City of Plymouth Planning Commission

Regular Meeting Agenda

**Special Land Use and
Site Plan Review
For
Plymouth, Michigan**

Applicant:	Bryan Bender Fortisnet Lease 30445 Northwestern Highway Farmington Hills, MI 48334
Project Name:	Scooter's Coffee Drive-Thru
Plan Date:	September 17, 2021
Location:	1490 W. Ann Arbor Road
Zoning:	ARC – Ann Arbor Road Corridor District
Action Requested:	Special Land Use and Site Plan Approval
Required Information:	Any deficiencies are noted in the report.

SHEET# SPA-2
 DATE: 20 SEPT 21
 JOB# 21041

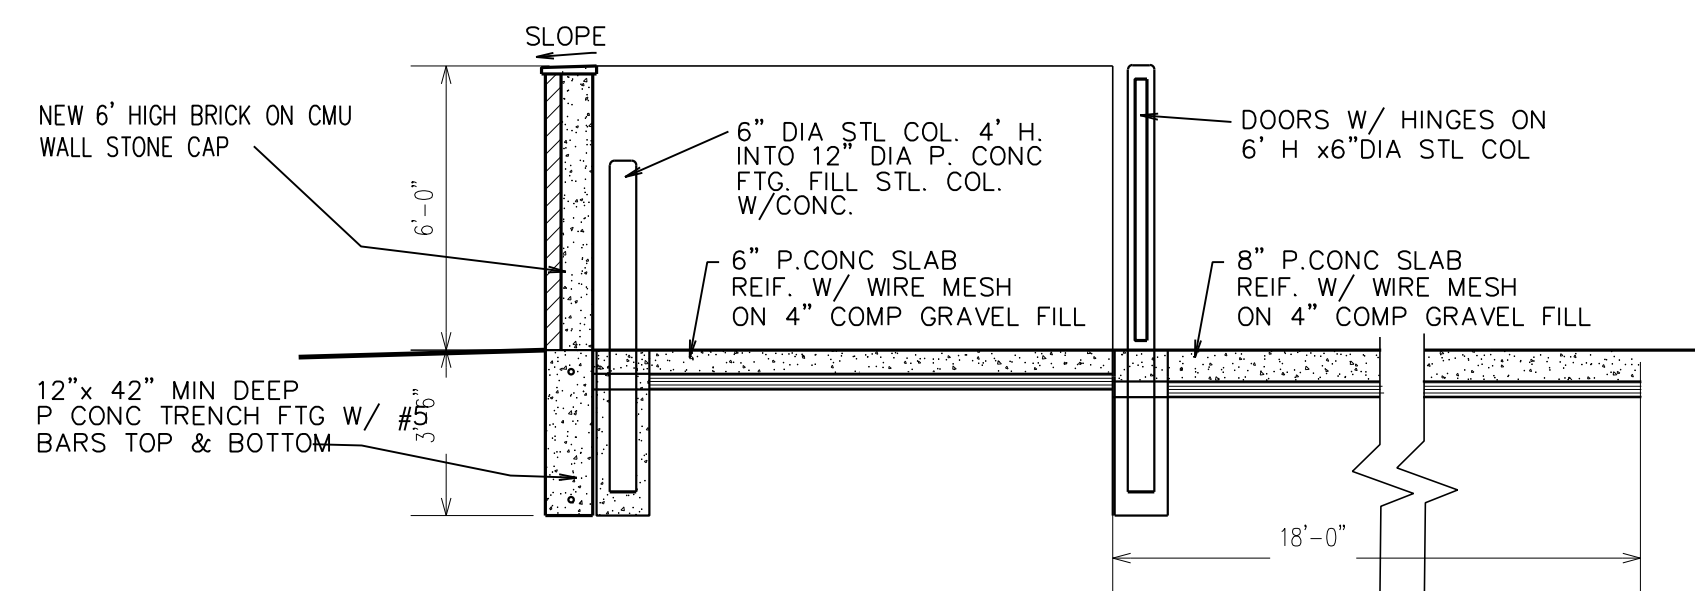
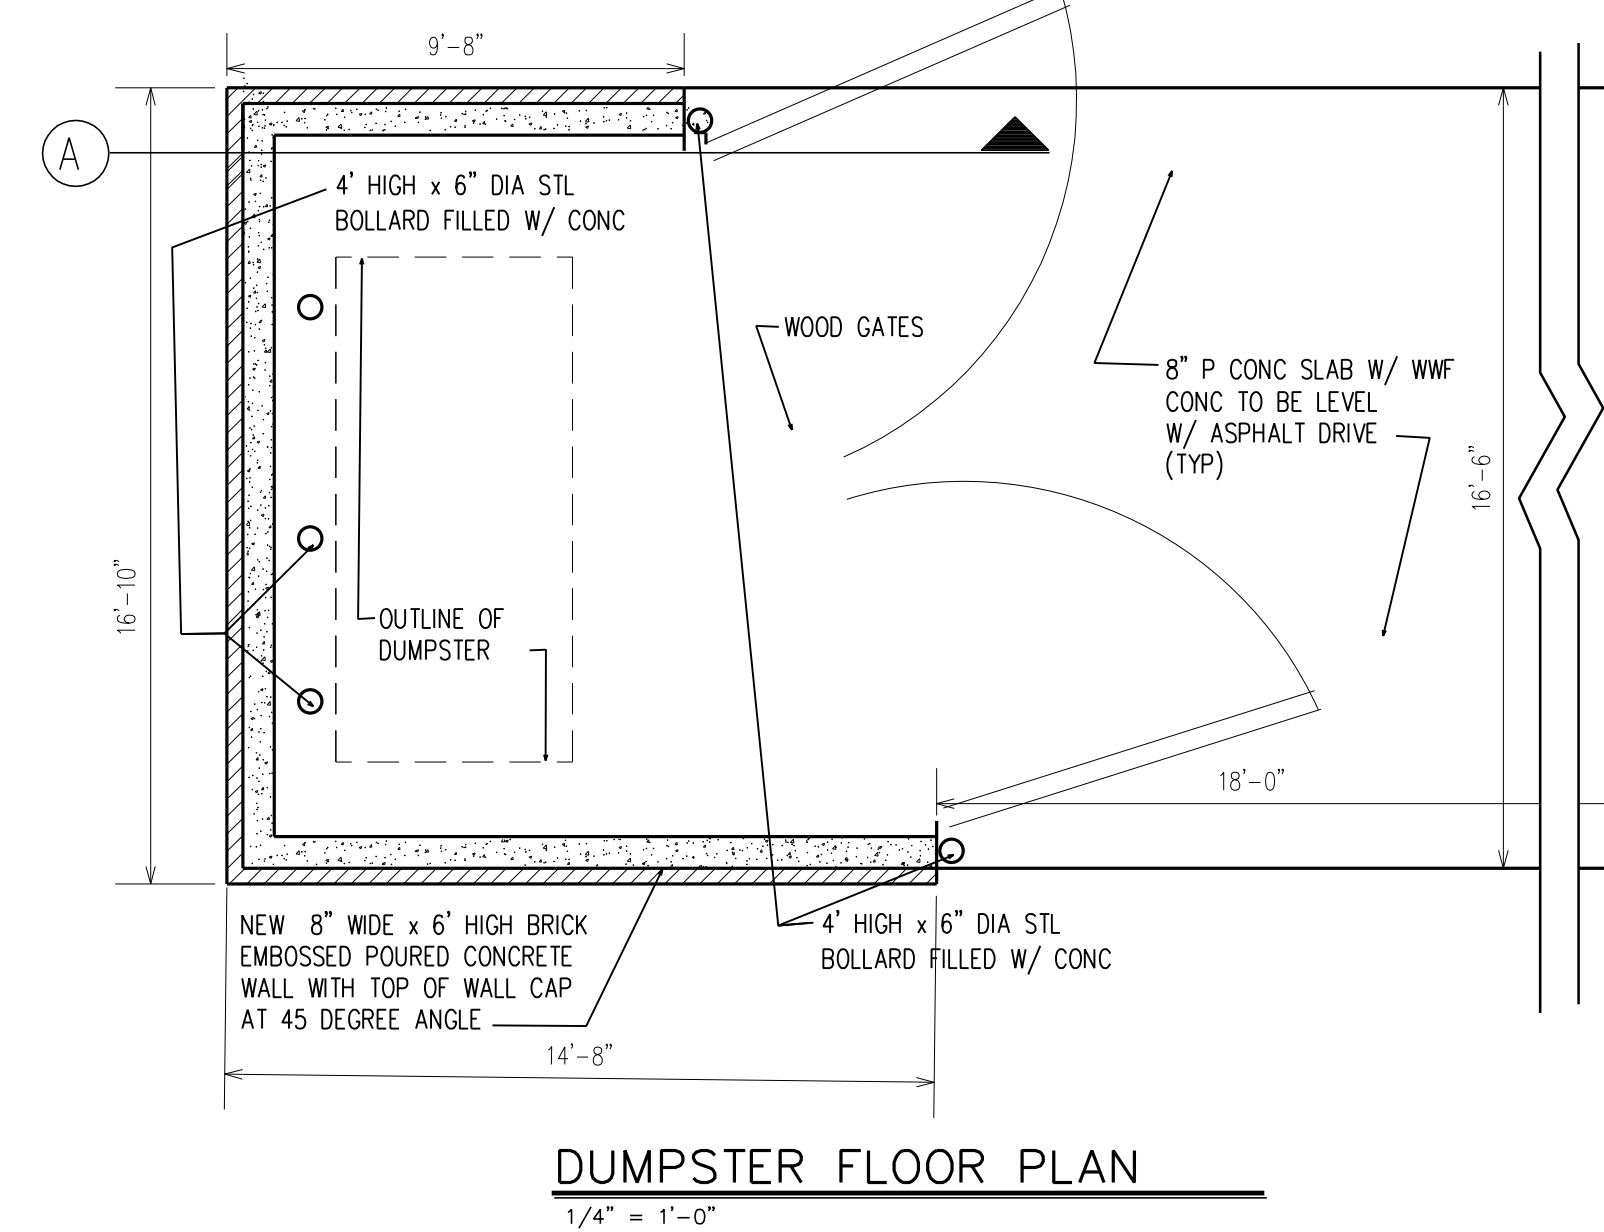
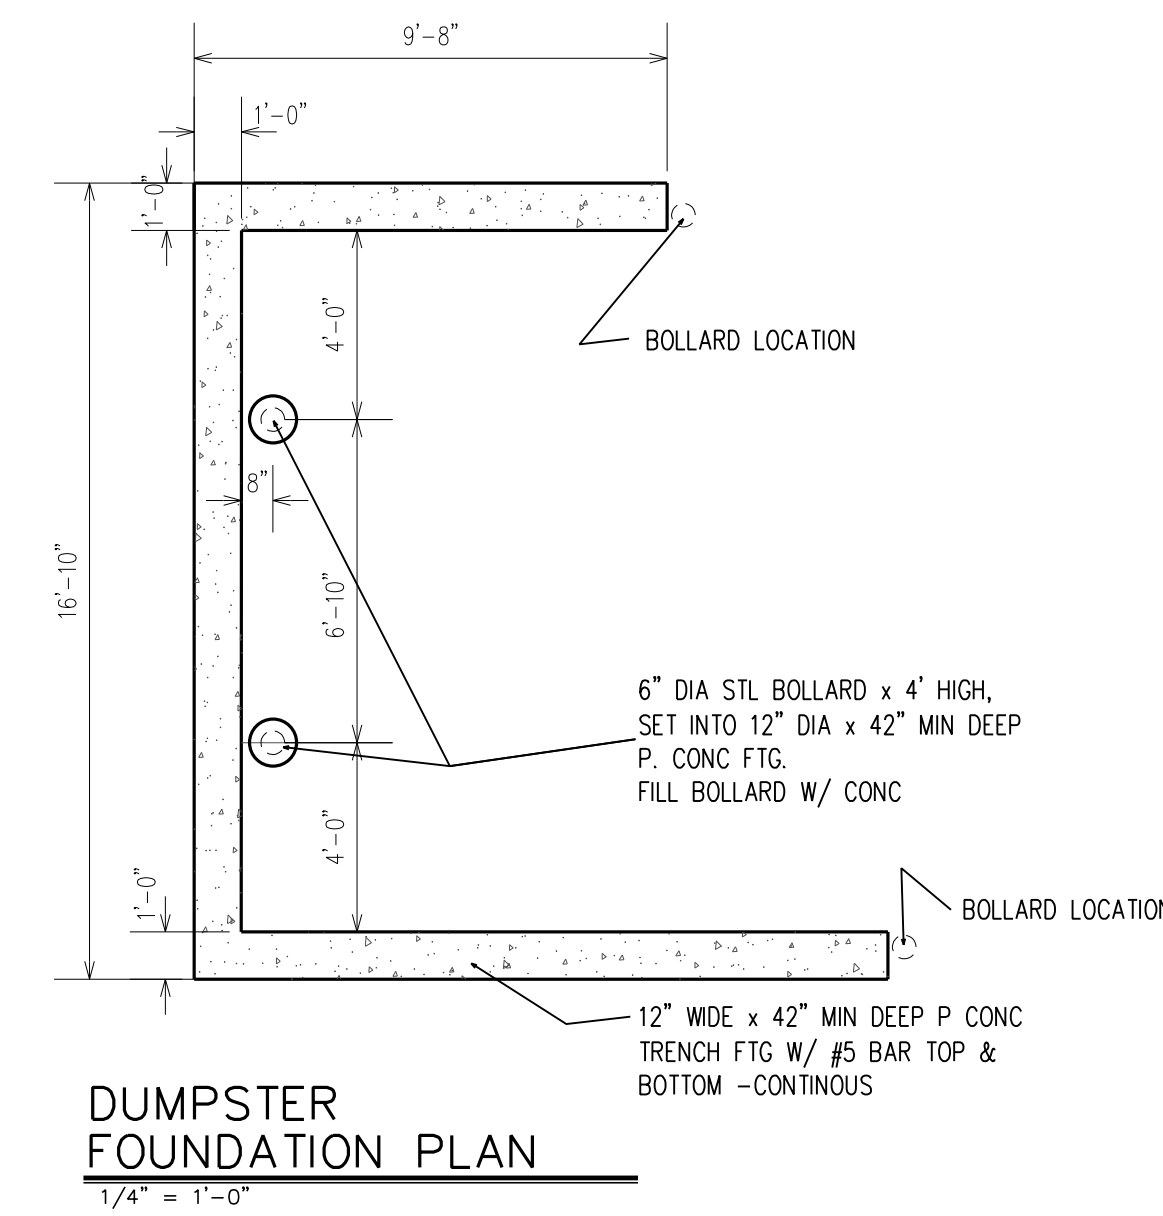
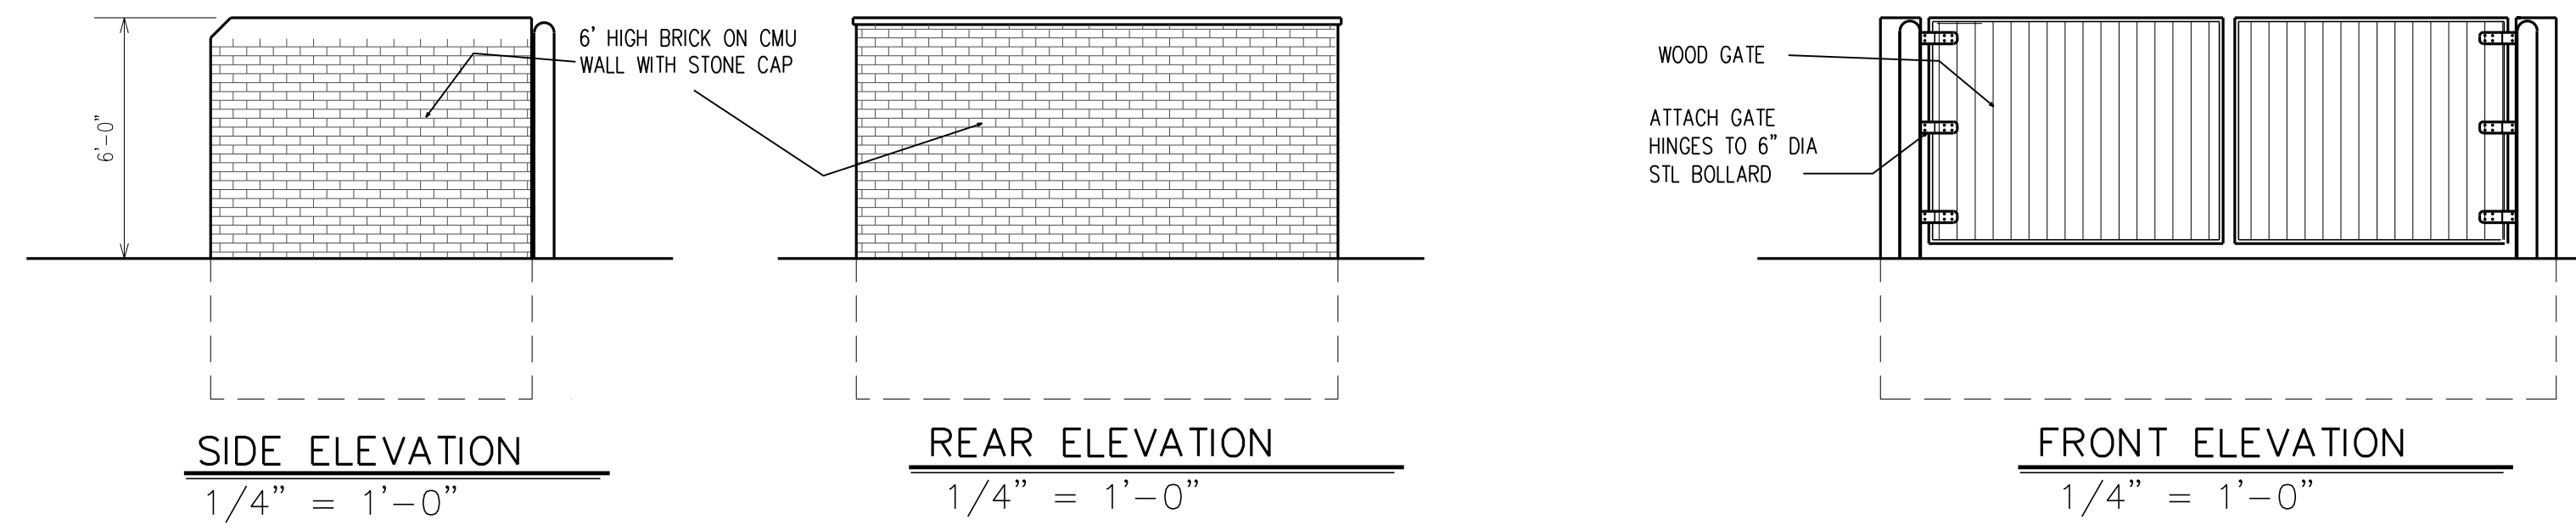
The plans show a new dumpster screen at the existing dumpster location (northwest corner of the parking lot). The dumpster screen detail (Sheet SPA-2), describes the wall as a “high brick embossed poured concrete wall.” This detail also matches a new small segment of screen wall, proposed to extend the wall installed by Westborn Market along their loading area. The applicant should confirm that the Westborn Market wall is also an embossed poured concrete wall, or if it is a CMU wall with face brick. The wall, and dumpster screen, proposed for this project should be consistent with the Westborn Market wall.
